Campaign No. 2022010007, January, 2021

SUBJECT: **Model 907 Sprinter, Model Year 2021**
Tighten Spring Loaded Rear Step

Order No. V-RC-2022010007

D88.30-A047-79

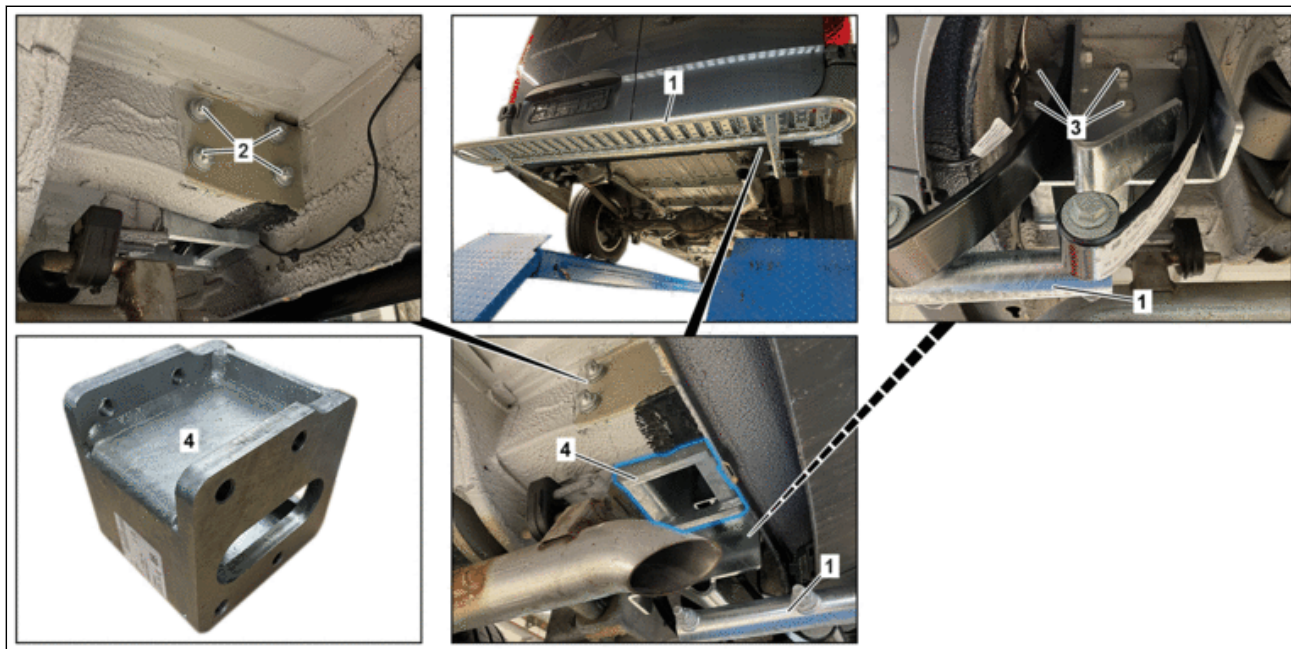
1 Spring-mounted step
 2 Bolts

3 Bolts
 4 Fastening bracket

| 4 | Replace mounting support (4) of spring-mounted step (1). |  To do so, remove screw/bolts (2, 3). Replace screws (2, 3) too.  Screw/nut, sprung running board to longitudinal member | BA88.30-Z-1001-03KTS |

| Number | Designation | Model 907, 910 |
|----------------------|--|----------------|
| BA88.30-Z-1001-03KTS | Screw/nut, sprung running board to longitudinal member | 94Nm |
